HISTORIC LANDMARK COMMISSION
STAFF REPORT

Petition 470-08-08 Lawrence House Legalization
Located at 285 North "C" Street in the Avenues Historic
District
April 2, 2008

Planning and Zoning
Division
Department of Community
Development

Figure 3 - Original Window Profile

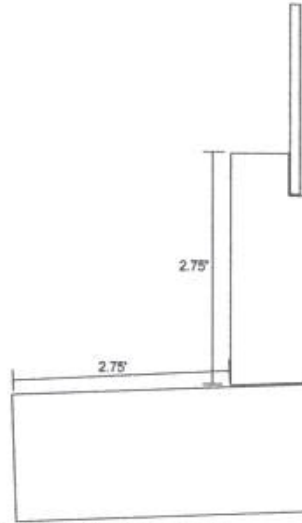
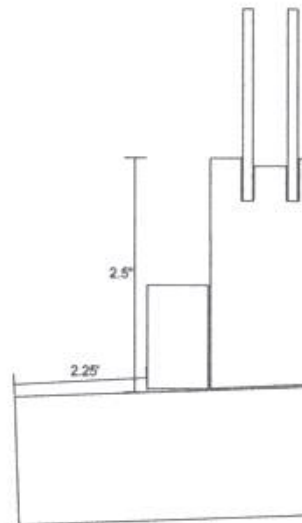
Replacing historic windows with vinyl is considered on a case by case basis. In determining if a replacement vinyl window is appropriate, the manner in which a window is replaced and the amount of original material removed are considered. Important items to consider include preserving the original casing, the amount of glazing to be diminished, the proposed finish, and the profile of the proposed replacement window. In this instance, the applicant replaced only the sash of the window. The original

casing was preserved. The amount of glazing is similar. The finish is a smooth vinyl. The profile of the window is similar to the original (refer to Exhibit C).
